3411 FAIRPLAY

SITE PLAN

COVER SHEET

DATE : 03/01/2022

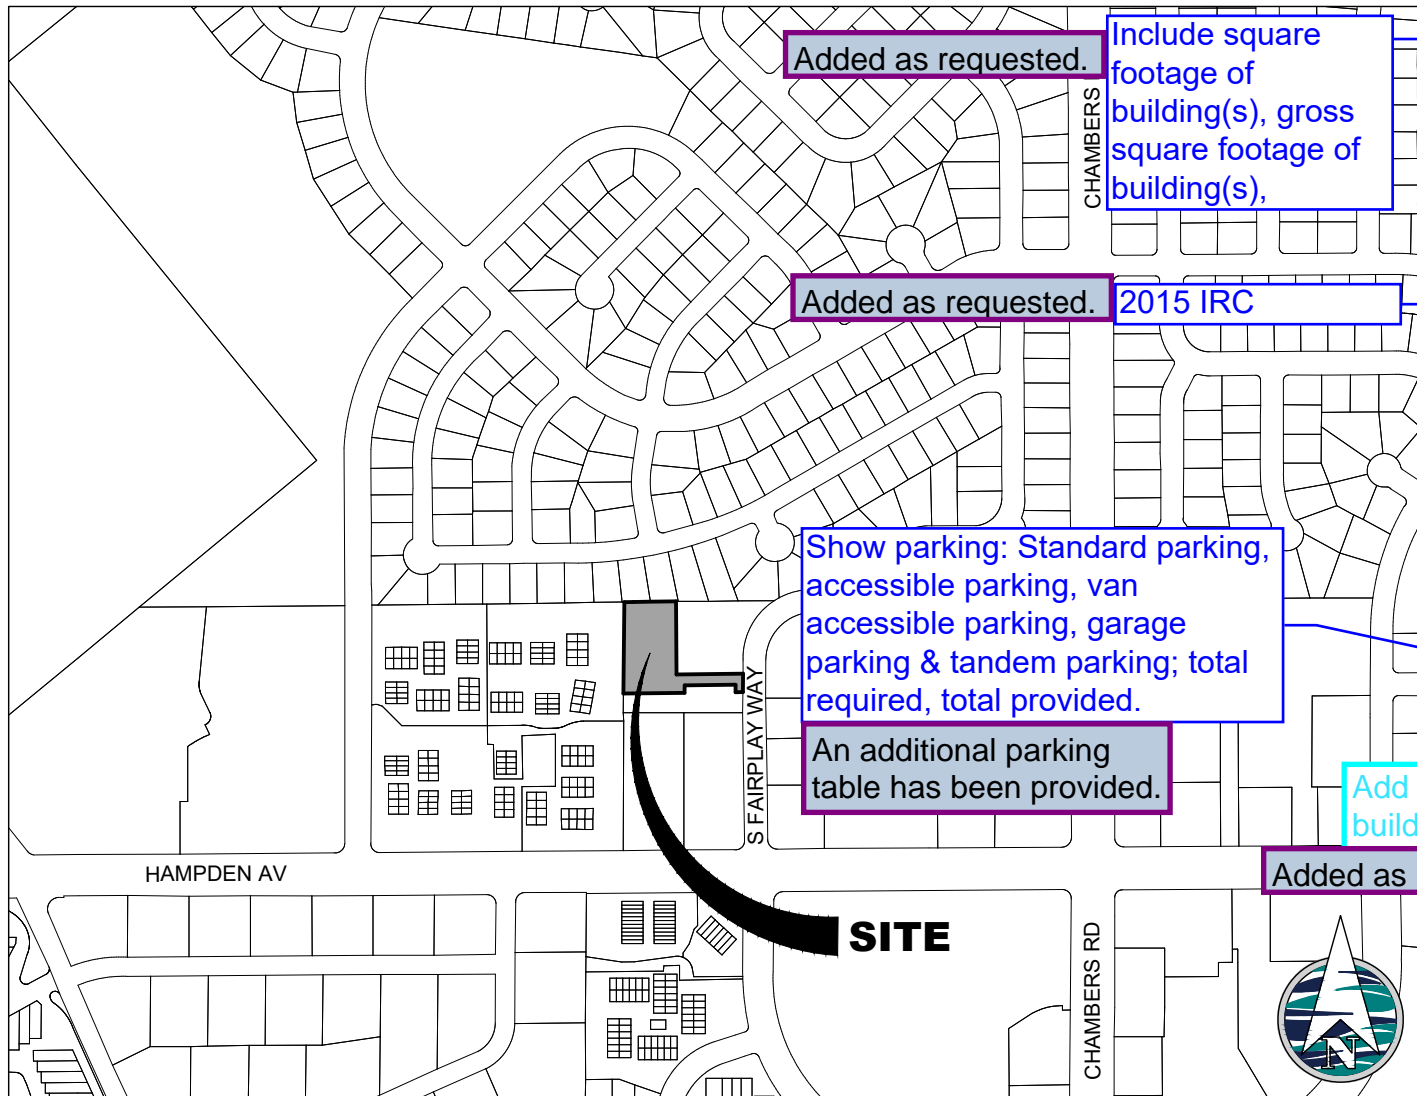
Can be made 24" x 36" for Arapahoe County

The site plan will not be approved by public works until the preliminary drainage letter/report is approved

Provide a 1"x3" rectangle area in the upper right corner of the cover sheet for Arapahoe County Clerk & Recorder Sticker.

Turn off autocad

Match the subdivision plat description.

See note at upper right hand side of this sheet.

Add the landscape architects contact information.

Revised to be 24" x 36"

Comment noted

Once comments are completed I will gladly turn off autocad.

Language has been revised to match plat description.

This recorders certificate has been relocated to the upper right hand side of the sheet with along with an addition of the 1" x 3" rectangle outlined by dots.

Landscape contact info has been added.

3411 FAIRPLAY
A PORTION OF LOT 2, SPINNAKER SUBDIVISION FILING NO. 2
SITE PLAN

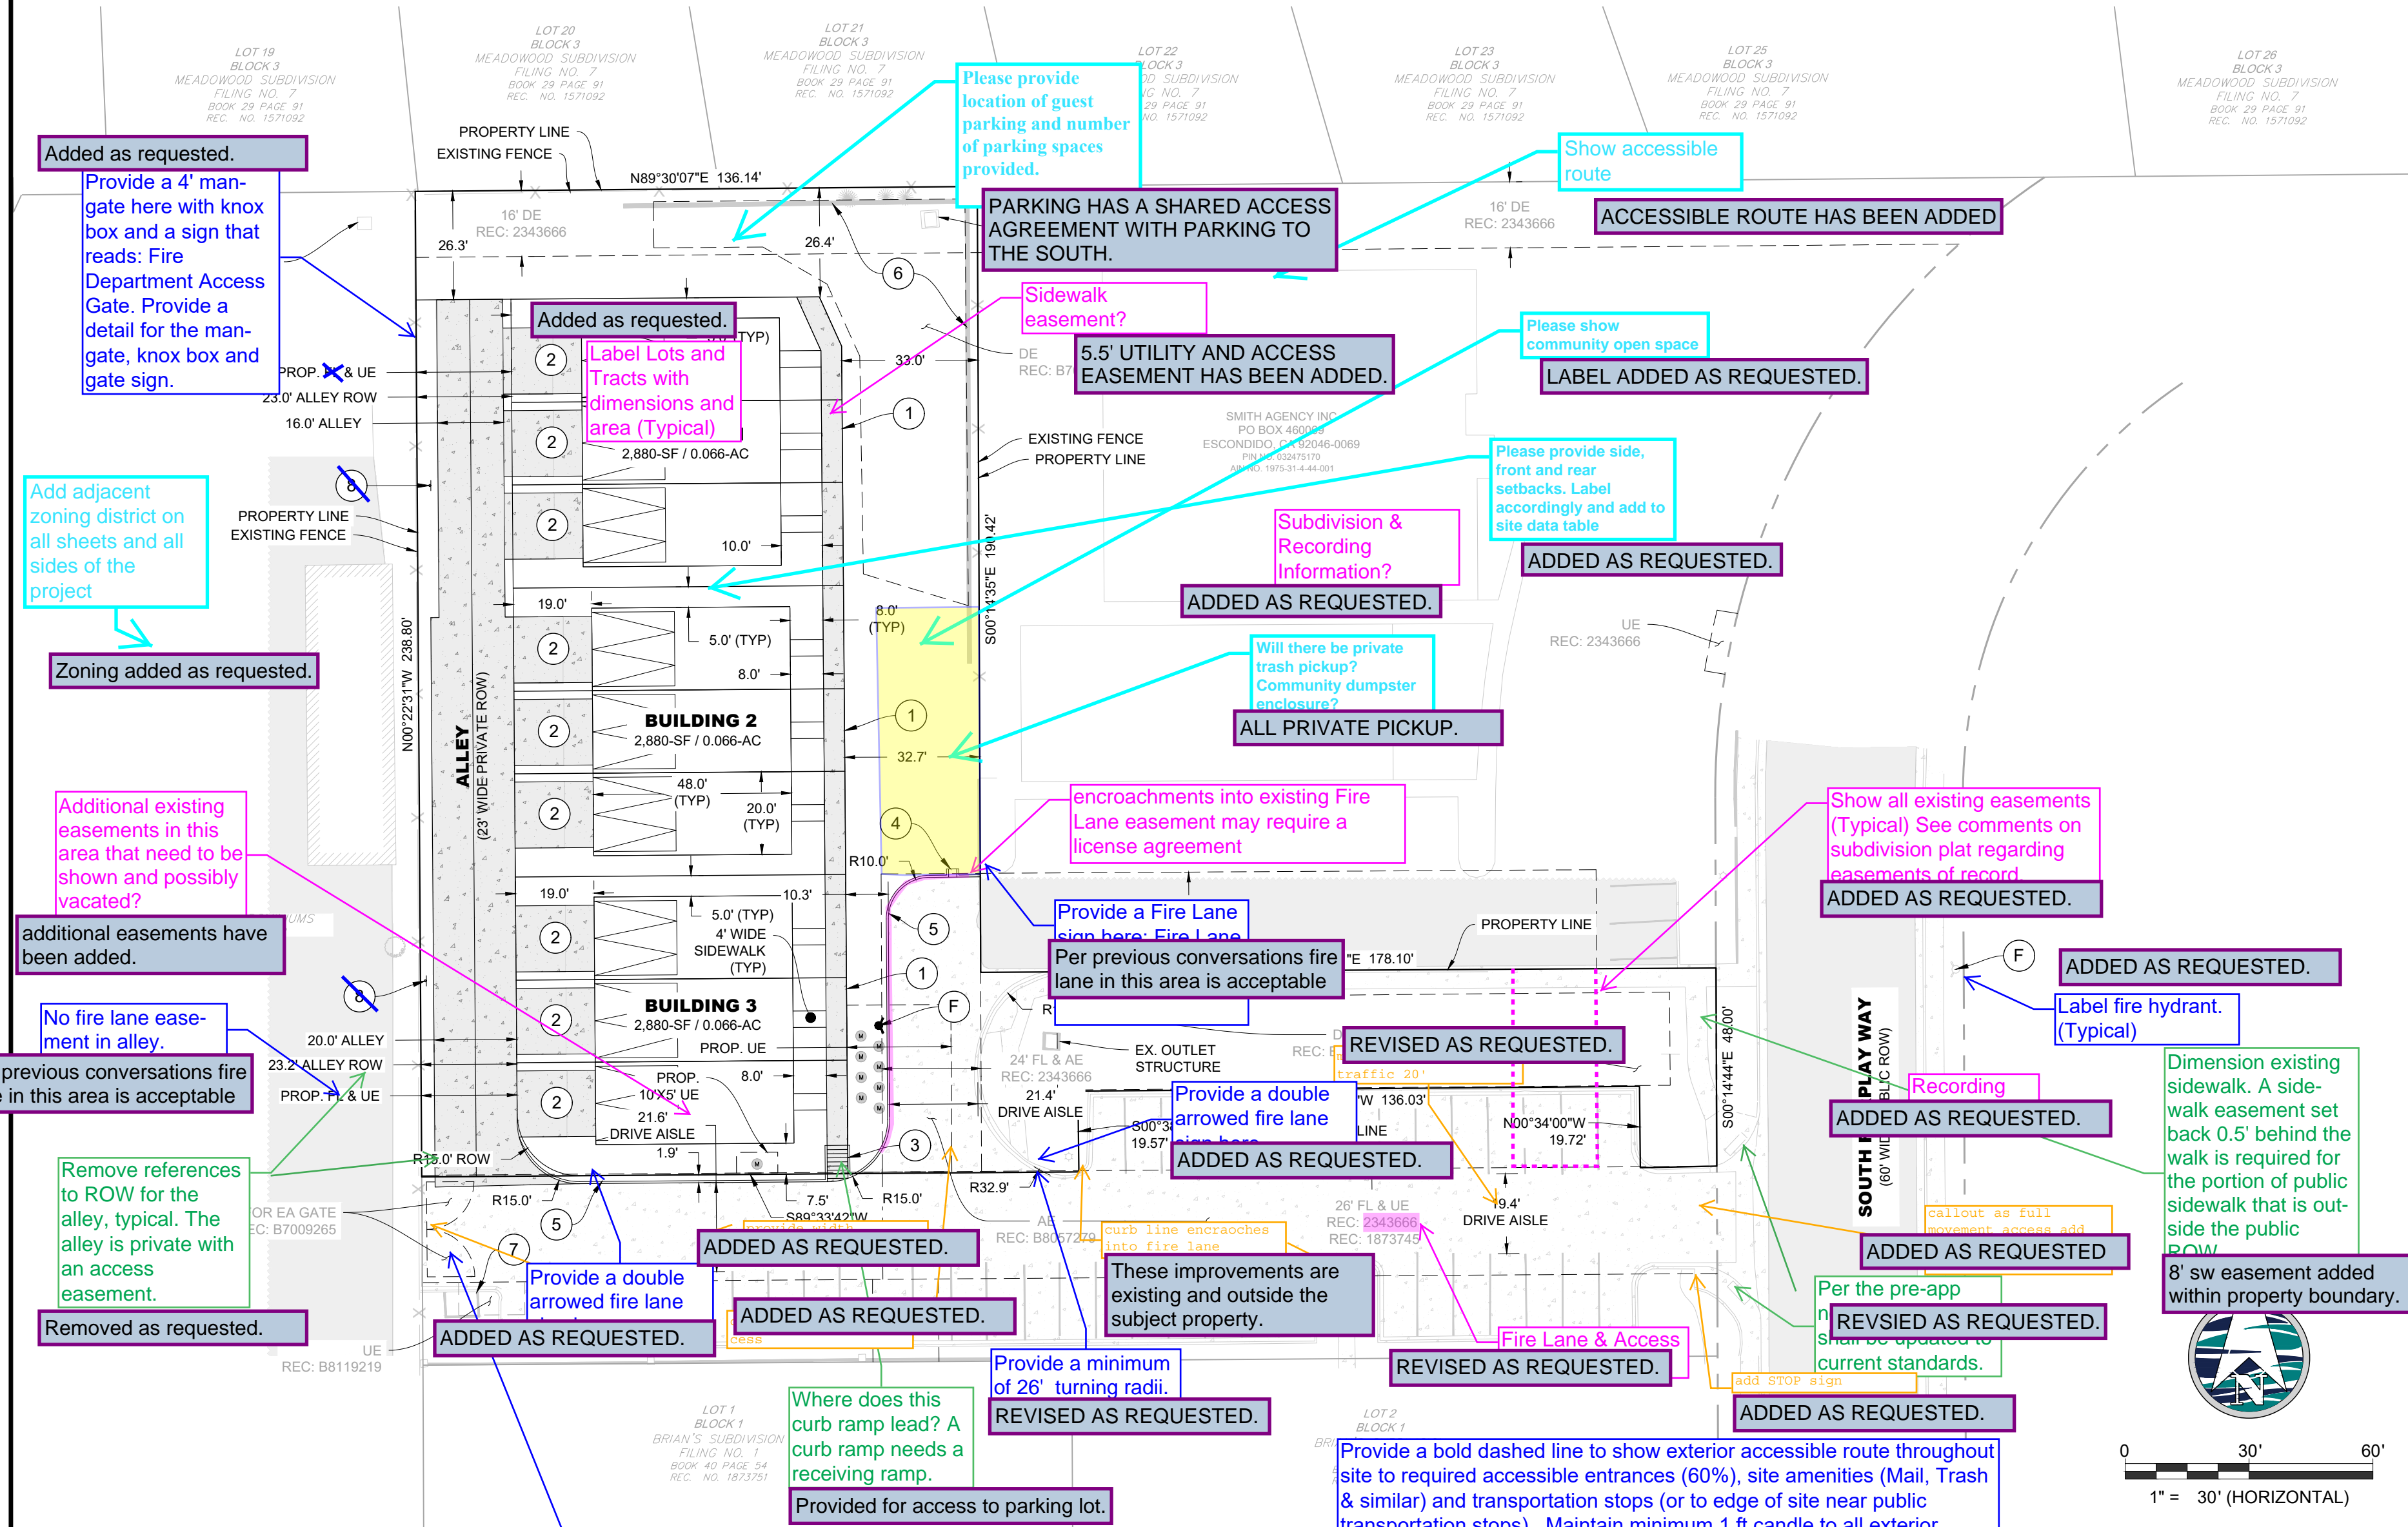
Label the type of gating or barricade system being installed on the site plan using one of the following examples: (New or Existing?)

- (2) 13' Automatic Sliding with approved Siren Operated System, Knox Key Switch and Manual Release.
- (2) 13' Manual Swinging Gate with Approved Knox Hardware.
- (2) 13' Manual Sliding Gate with Approved Knox Hardware.
- (2) 13' Electrical Sliding Gate with Approved Knox Hardware.

We will work with the neighboring property to coordinate a 13' manual swinging gate with knox hardware. Callout added to Site Plan (SP1)

PHOTOMETRIC PLAN

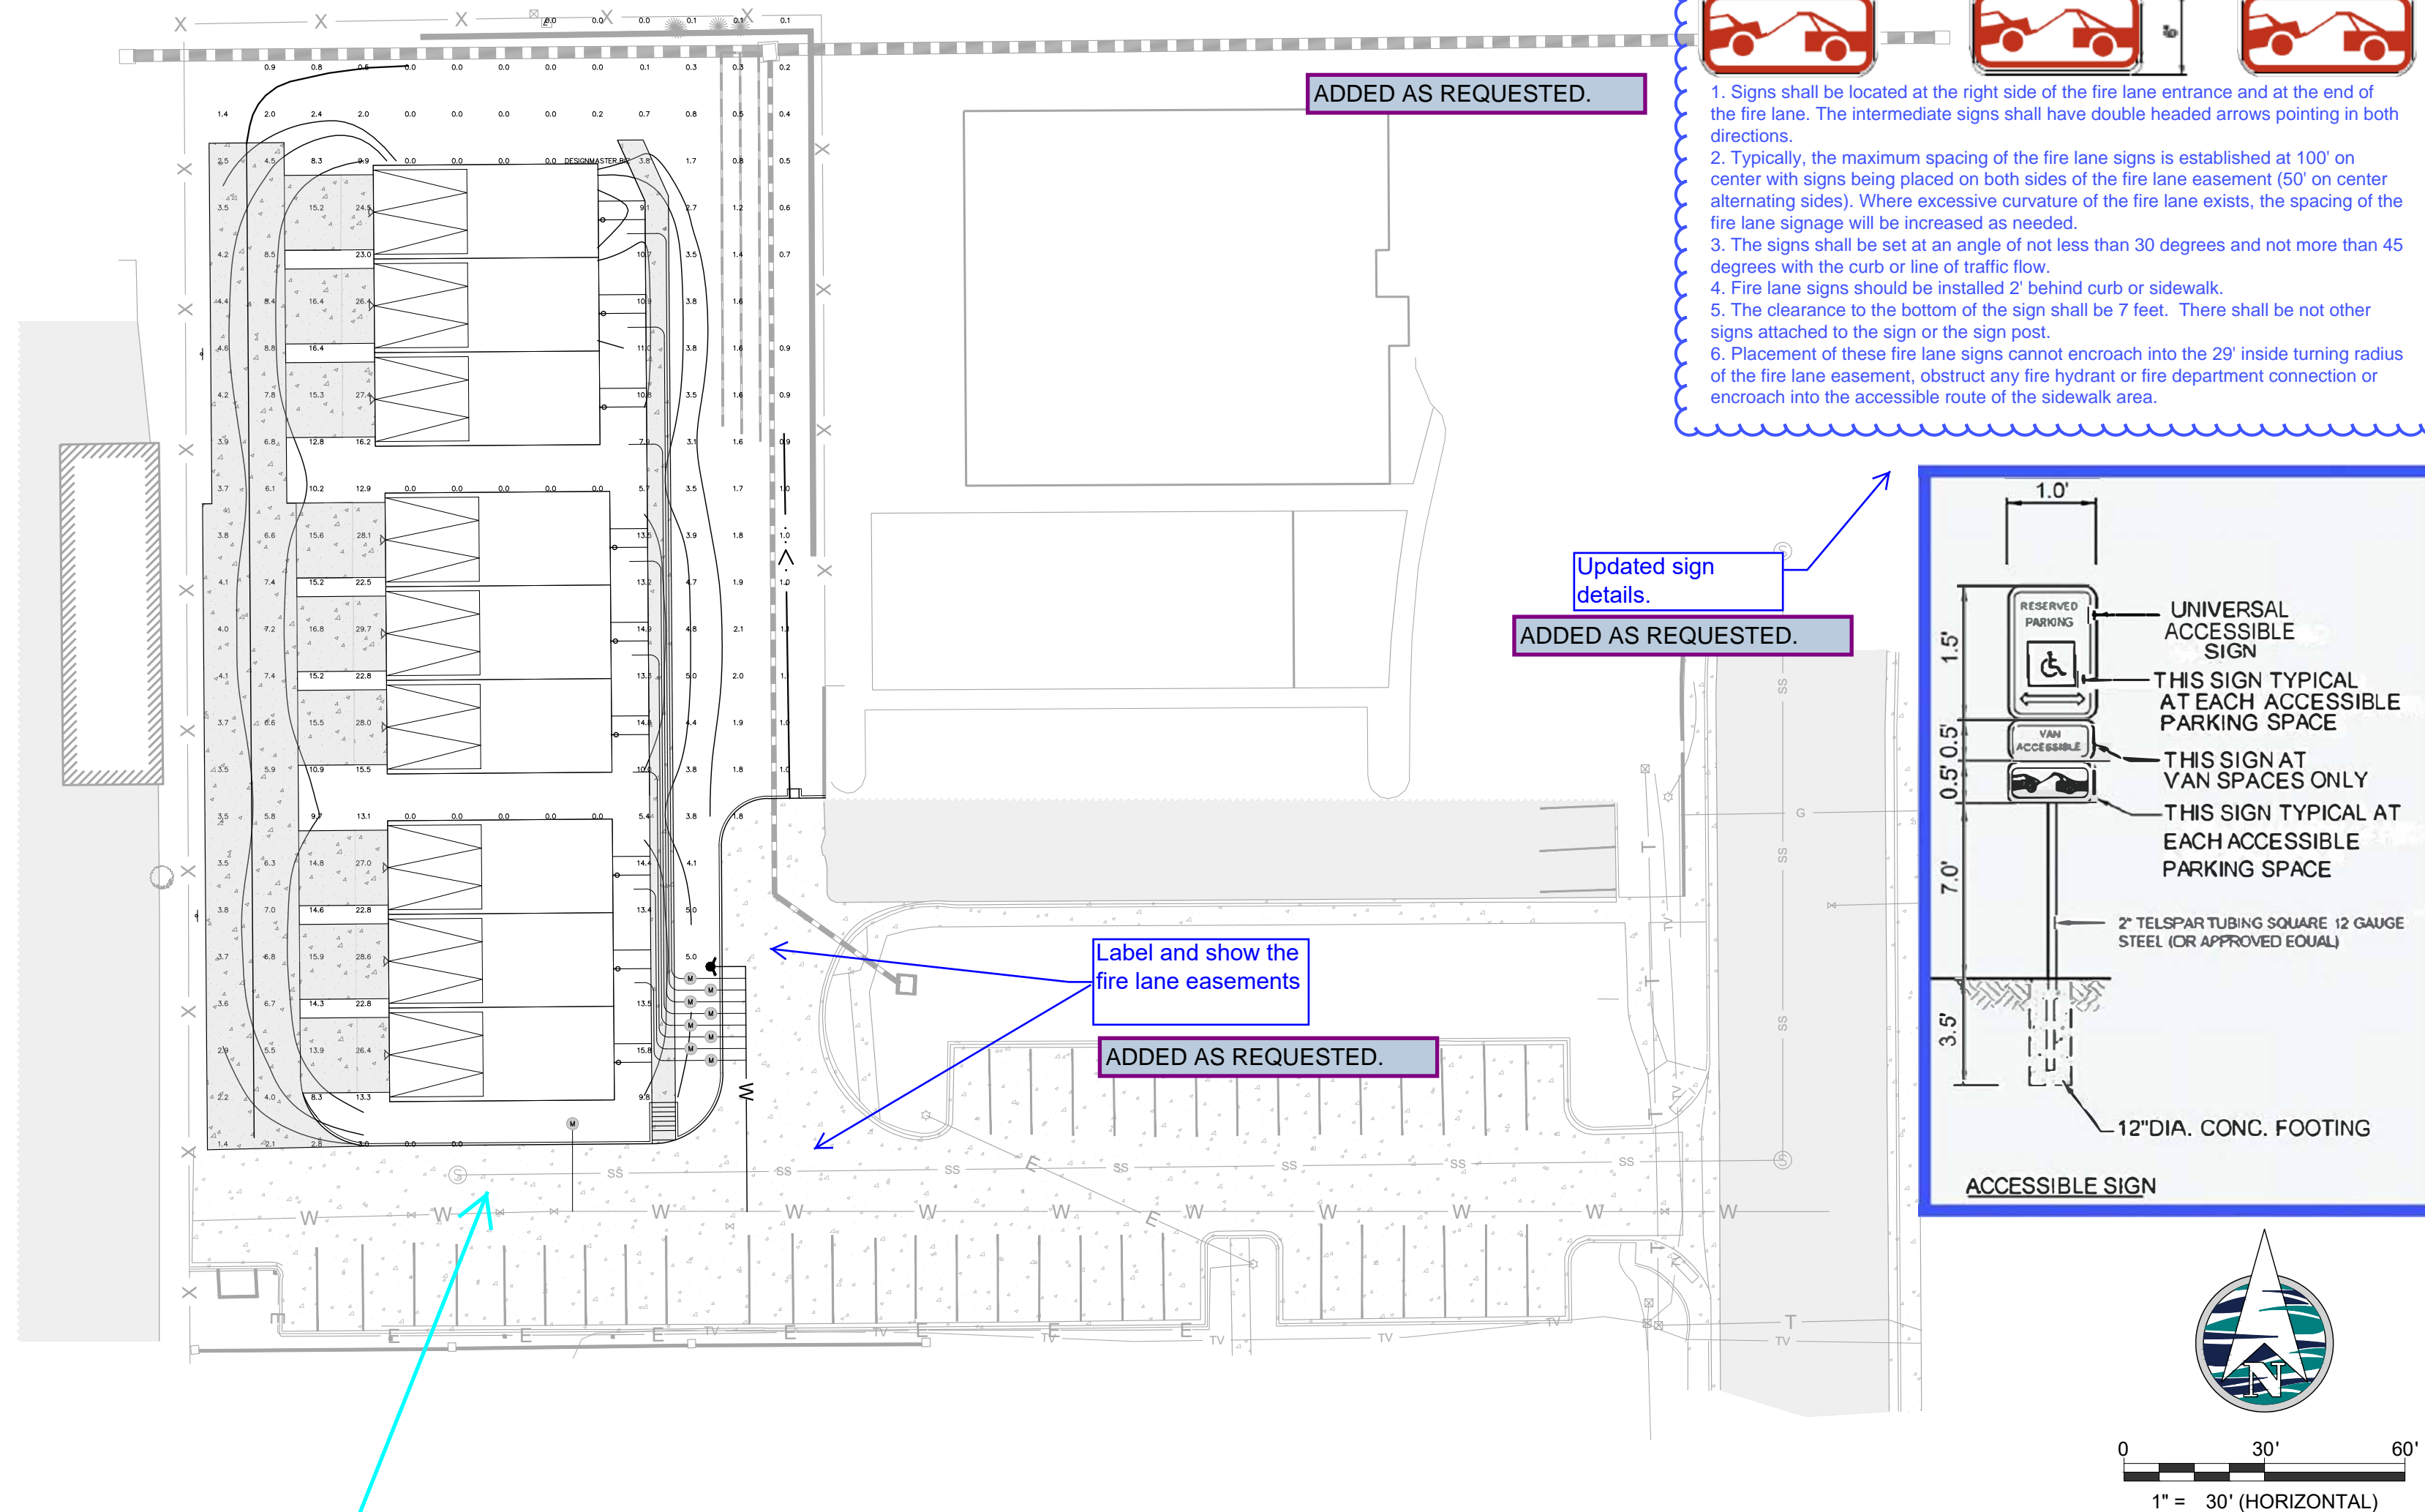
Please provide lighting cut-sheets with the next submission.

ADDED AS REQUESTED.
